AC HOTEL ORLANDO GATEWAY

SUMMARY

Staff recommends approval of AC Hotel Orlando Gateway—MPL2022-10005 subject to the conditions below.

Site Plan

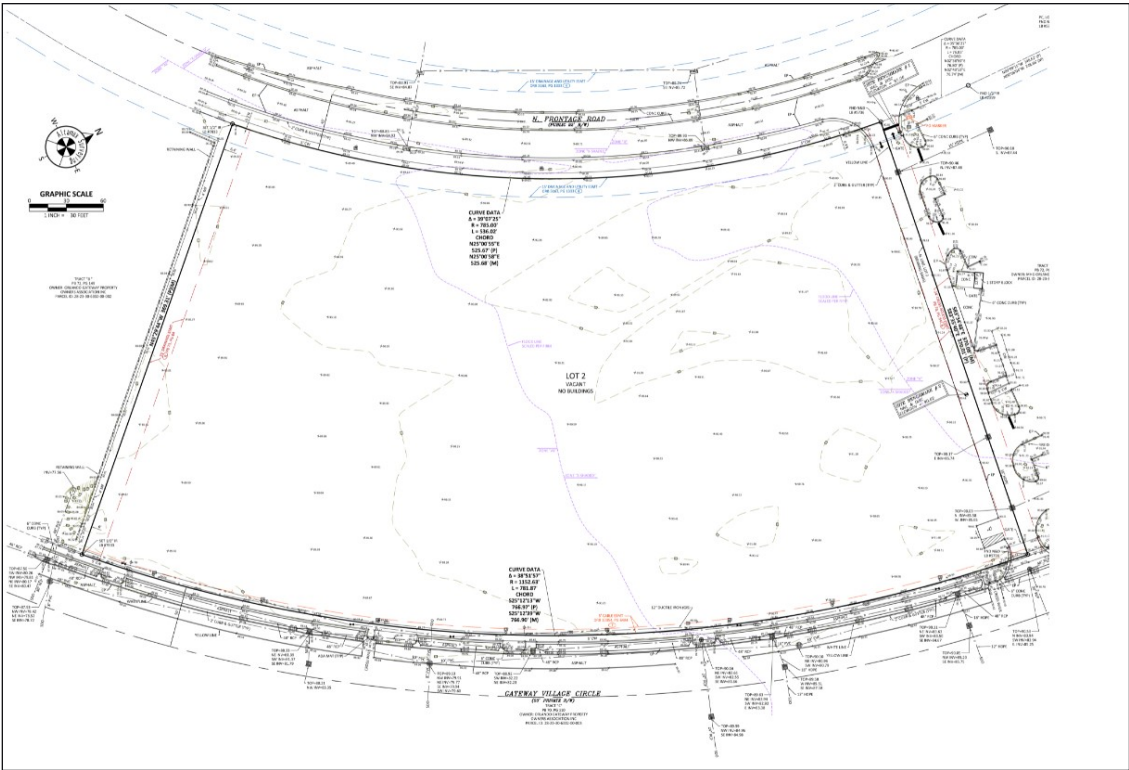
1. Pedestrian connections are required to both street frontages, you are proposing no clear pedestrian zone from the sidewalk on Gateway Village Circle to the front door.

8. Sidewalk connections must be provided from both N Frontage Rd. and Gateway Village Cir. to the sidewalk planned around the building.
9. On-site sidewalks must be a minimum of 5 ft. or 6 ft. wide when adjacent to drive aisles or parallel parking and 7 ft. wide when adjacent to parking stalls unless wheel stops are used. As shown several sidewalks adjacent to the drive aisles are only 5 ft. in width and must be expanded to 6 ft.

Proposed Landscape Plan

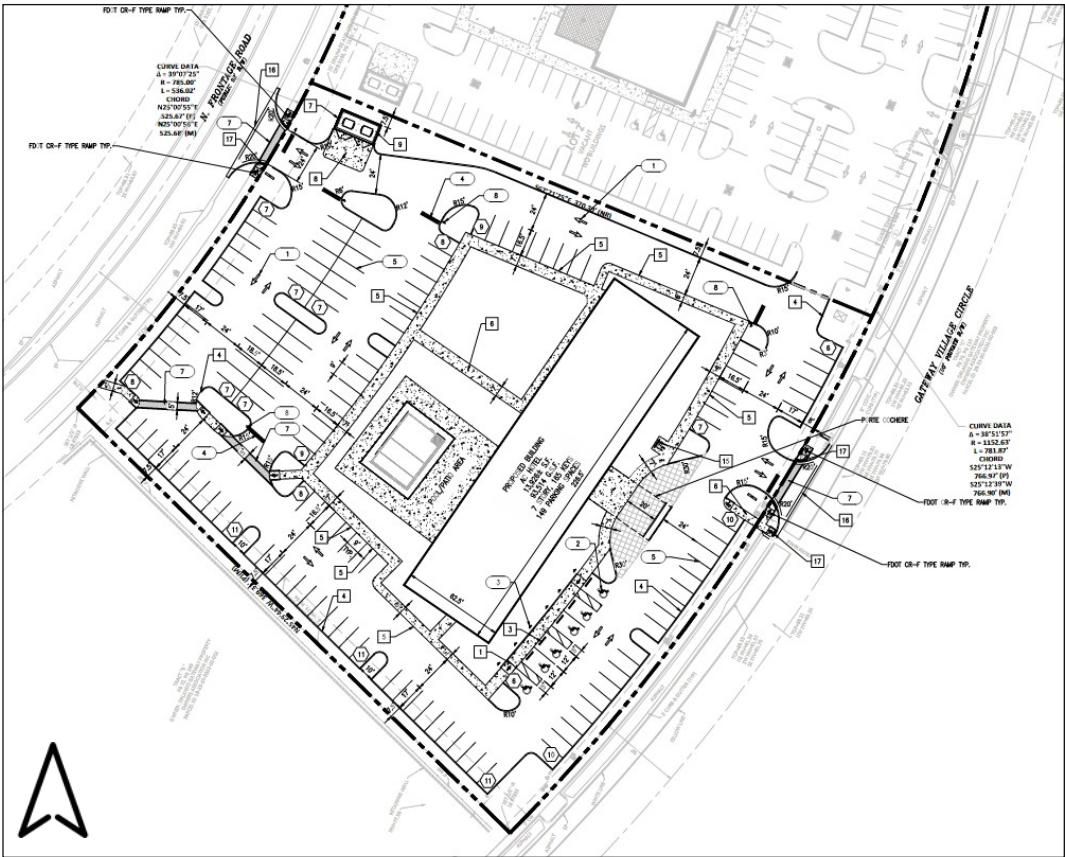
3. Canopy trees must also be planted every 50 lineal feet or fraction thereof. Required trees do not have to be uniformly spaced as long as the required number is provided. Currently, you have only provided understory trees along Gateway Village Circle.

4. Street trees must be planted along both frontages, currently there is a deficient amount along Gateway Village Circle Road. Trees must be oak trees to match what has been planted on the rest of the street. Street trees must also be planted in the bulb outs on Gateway Village Circle.

5. The rear sodded area must be landscaped with a mixture of plantings such as canopy trees, understory trees, groundcovers and hedges. Sod alone is insufficient.

6. Staff encourages you to consider amenitizing the sod area in the back. This could include a dog park, benches, a basketball court, etc.
